Access Compliance Report

Public Rights-of-Way

Intersection ID: 45488	Main Street: CAPTAIN_ARDREY_RD	Cross Street: GINHOUSE_LN	Location: NE
ADA ID: A7917C04BDD4	Ramp Type: PerpDiag	Initial Pass/Fail: Fail	Overall Compliance: No
Severity Score: 33.75			
Codes/Mitigation Info/Possible Solution		Field Measurements/Component Compliance

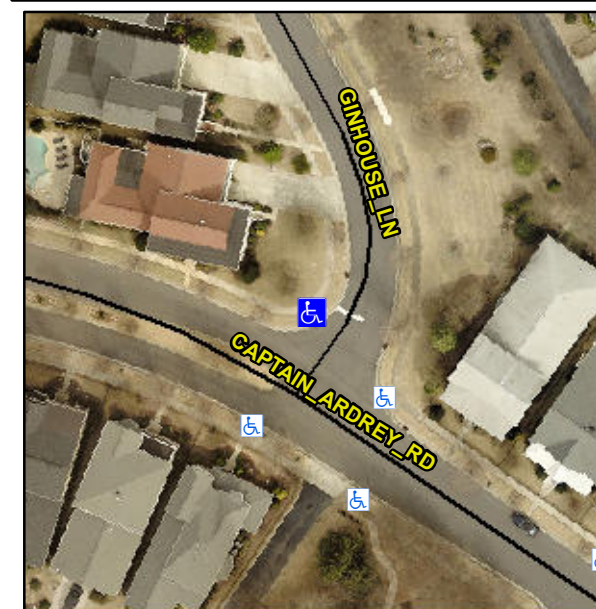
Not Found, R304.5.1, R304.2.2

Compliance	Description	Data	Compliance	Description	Data
N/A	Ramp Length (in)	74.0	No	Ramp Slope (%)	13.0
No	Ramp Width (in)	36.0	Yes	Ramp XSlope (%)	1.4
N/A	Flare Type LT	N/A	N/A	Flare Type RT	N/A
N/A	Flare Slope LT (%)	N/A	N/A	Flare Slope RT (%)	N/A
N/A	Flare Traversable LT?	N/A	N/A	Flare Traversable RT?	N/A
N/A	Landing Length (in)	N/A	N/A	DWS Provided?	N/A
N/A	Landing Width (in)	N/A	N/A	DWS Contrast?	N/A
N/A	Landing Slope (%)	N/A	N/A	DWS Length (in)	N/A
N/A	Landing X Slope (%)	N/A	N/A	DWS Full Width?	N/A
N/A	Landing Curb? (Y/N)	N/A	N/A	DWS Offset (in)	N/A
N/A	Shared Landing?	N/A			
N/A	Gutter Ponding?	N/A	N/A	Gutter Slope (%)	N/A
N/A	Gutter Lip Ht (in)	N/A	N/A	Gutter X Slope (%)	N/A
N/A	Painted X Walk1?	No	N/A	Painted X Walk2?	No
	X Walk 1 Direction	To SW		X Walk 2 Direction	To SE
N/A	X Walk 1 Width (in)	N/A	N/A	X Walk 2 Width (in)	N/A
	X Walk 1 Slope (%)	2.1		X Walk 2 Slope (%)	2.2
	X Walk 1 X Slope (%)	3.9		X Walk 2 X Slope (%)	0.4

Remove & Replace Curb Ramp With Two New Directional Ramps or Equivalent.
